RE: 9006 Eagle Rock Ave. NE
Grading and Drainage Plan
Engineer's Stamp Date: 08/17/20
Hydrology File: C20D056C

Based upon the information provided in your submittal received 08/18/2020, the Grading and Drainage Plan **is not** approved for action by the DRB for Preliminary Plat. The following comments need to be addressed for approval of the above referenced project:

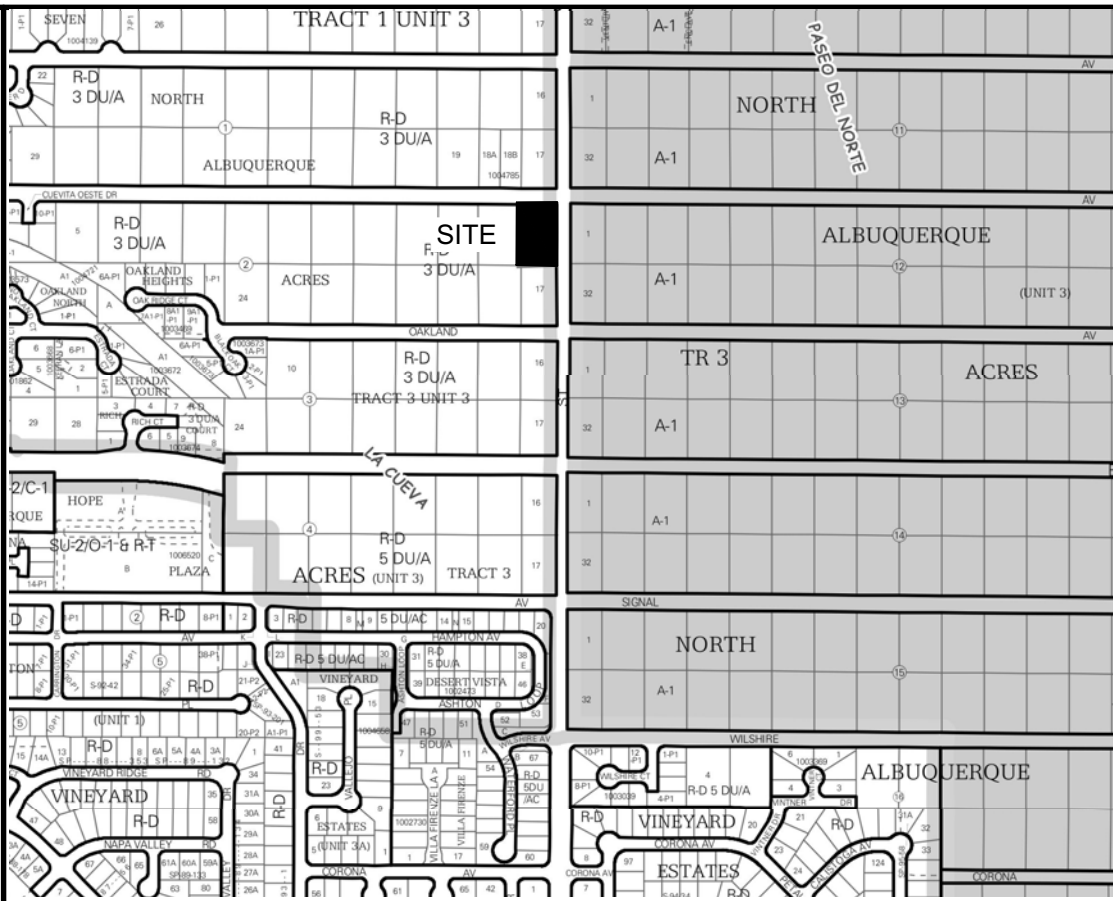
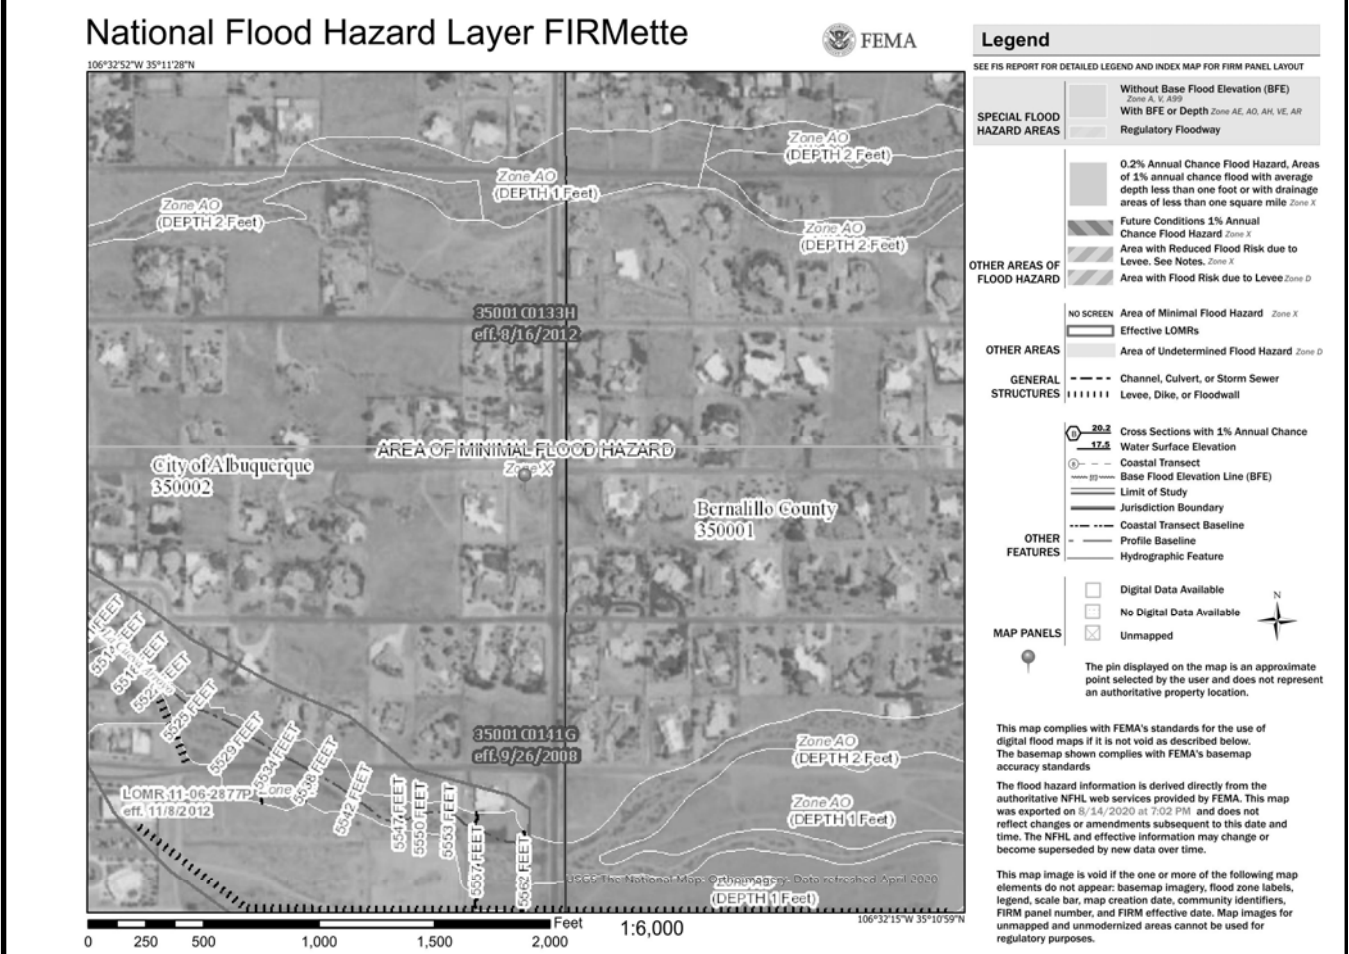
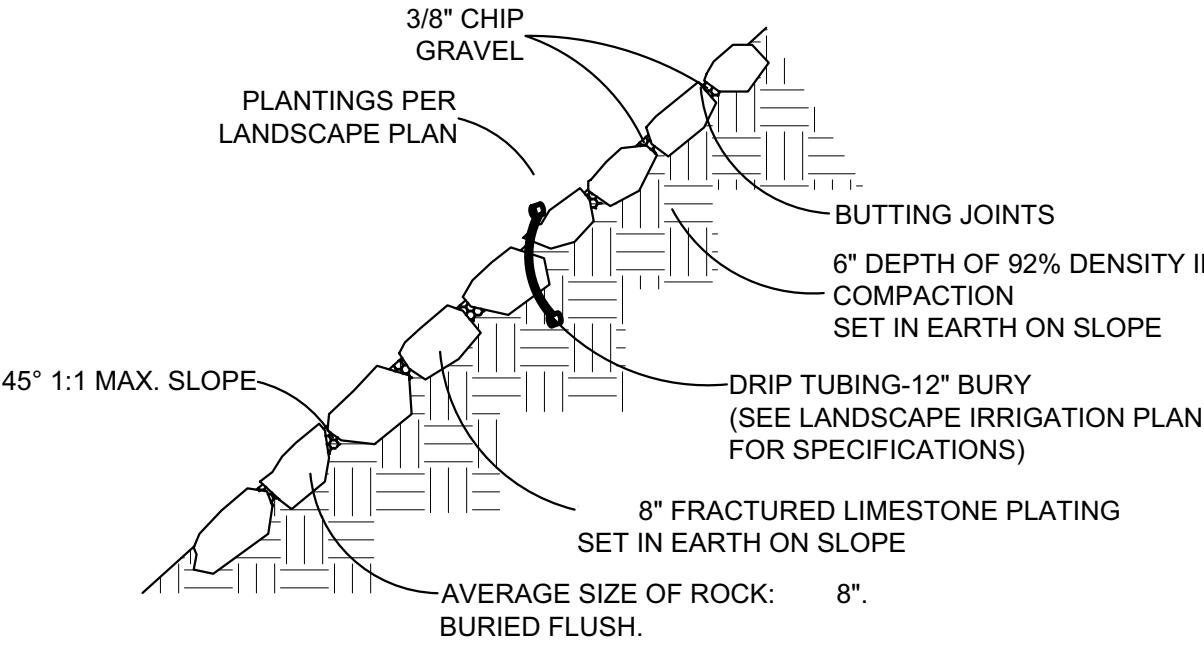
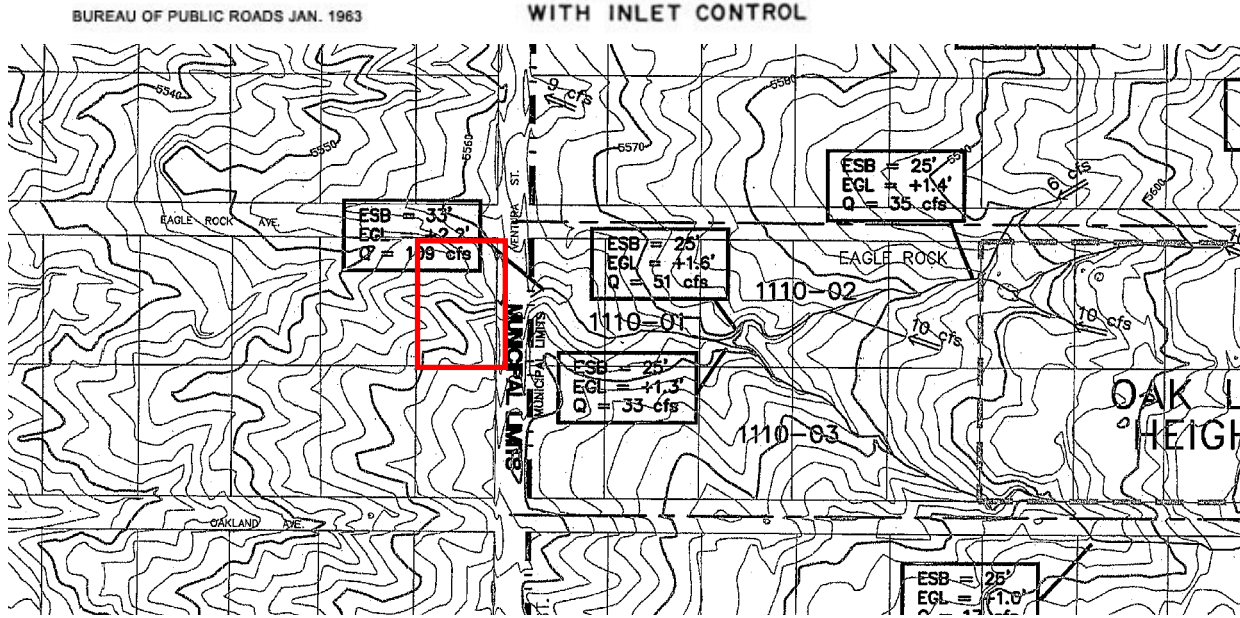
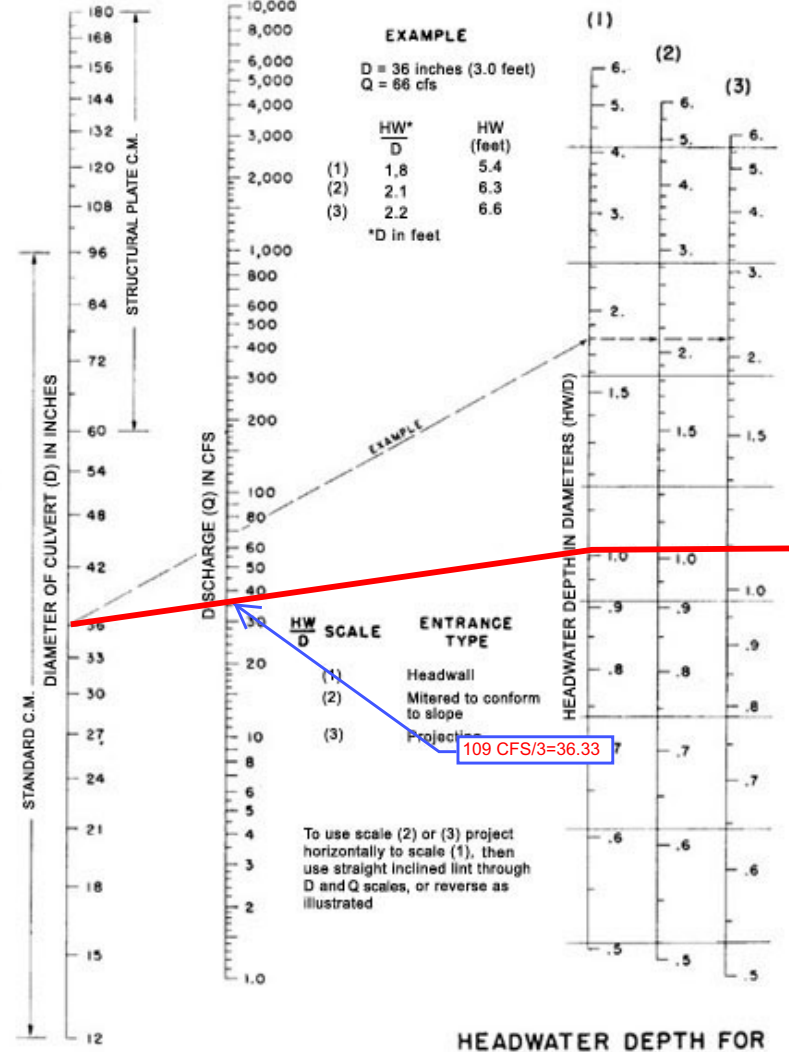
1. Per Section 1-7(B)(2)(e) of the IDO, infrastructure improvements are required. For this lot, that will include sidewalks, curb & gutter, and pavement on both Eagle Rock and Venture.

2. All infrastructure improvements that are needed per the IDO must be shown and designed on the Grading & Drainage Plan plus the infrastructure list will need to be approved by the DRB.
3. And as per the NAA MDP, the drainage will travel north on Venture then west along Eagle Rock with the roadway improvements to the storm drain downstream on Eagle Rock before entering La Cueva Channel.
